A/E Firm: WRA Architects		PM Firm: CBRE Vanir JV	Date: 12-10-2025
Org #: 159	School Name: L.L. Hotchkiss Elementary School	Bid Pack #/ CSP#: 207325	Addendum #: 1

**DALLAS INDEPENDENT SCHOOL DISTRICT
PROCUREMENT SERVICES
ADDENDUM NO. 1
CSP 207325 – L.L. Hotchkiss Elementary School - Renovation**

The Purpose of this Addendum No. 1 is to provide an alternate bid and updated the drawings and specifications:

Overall Work Area Plan	
------------------------	--

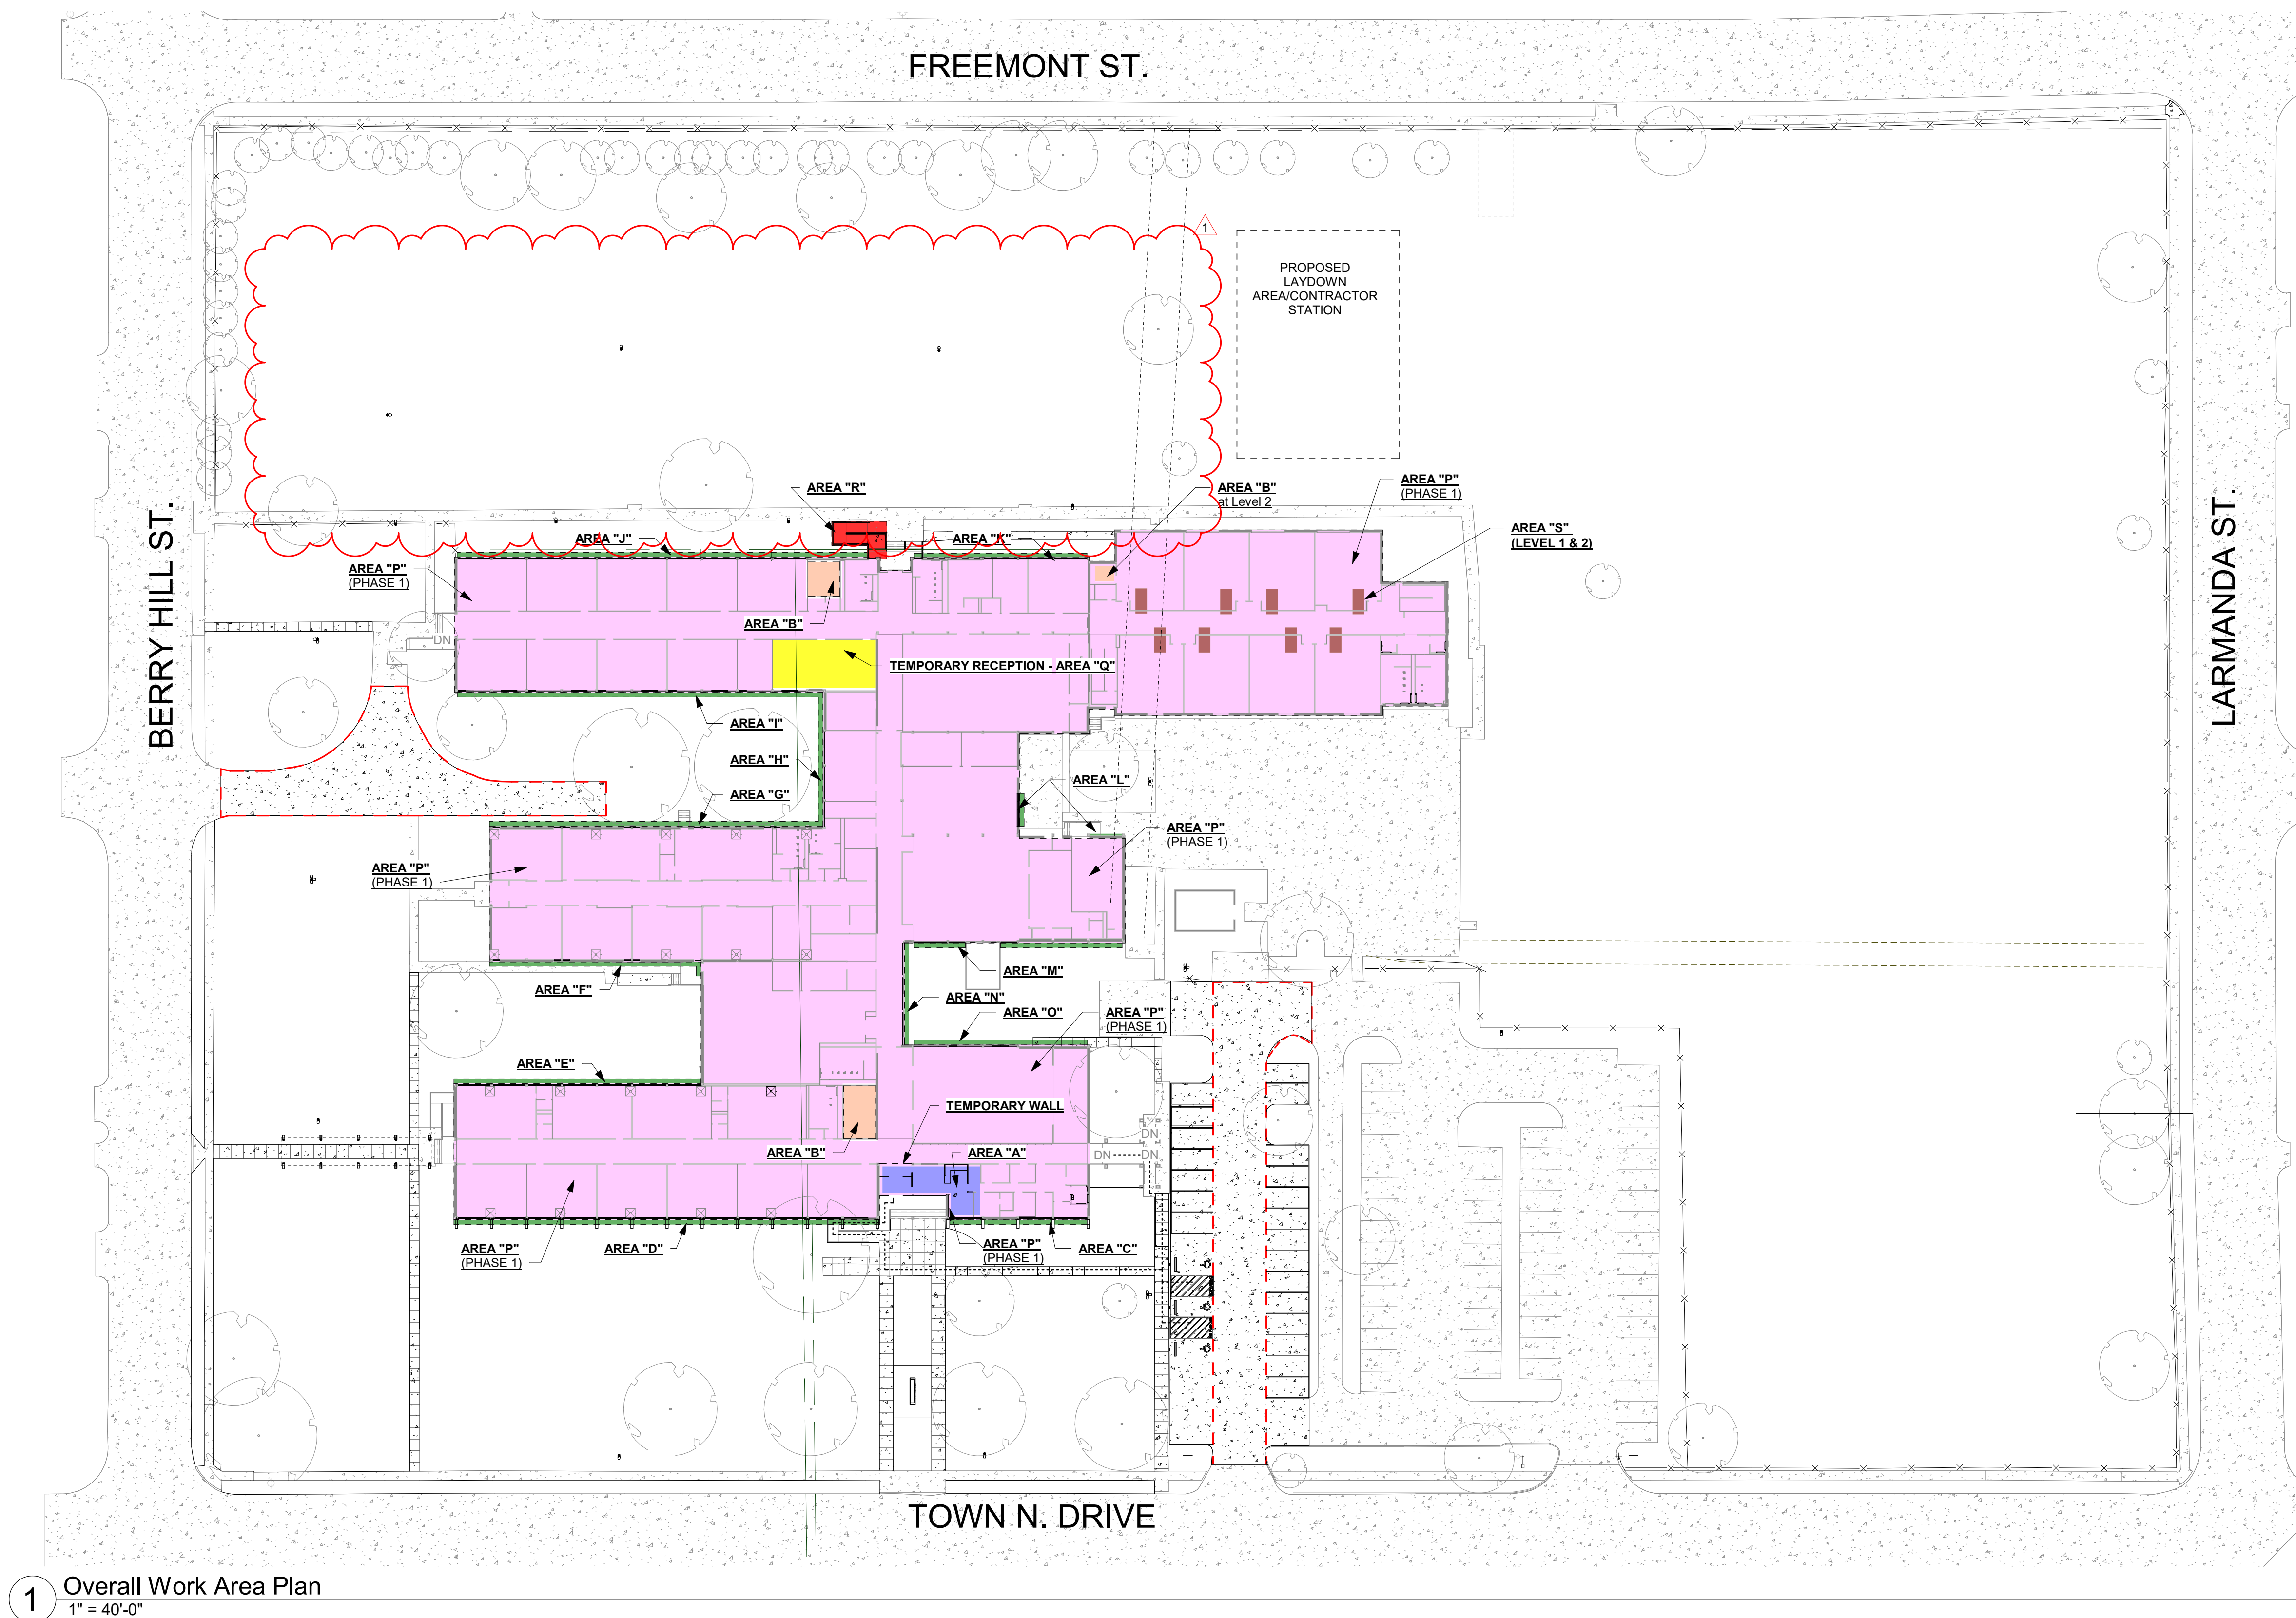
- A.** Provide a minimum of 275' extension of conduit and cabling to existing PA, existing PA to be relocated to temporary admin area. Reference A102 – Overall Work Area Plan
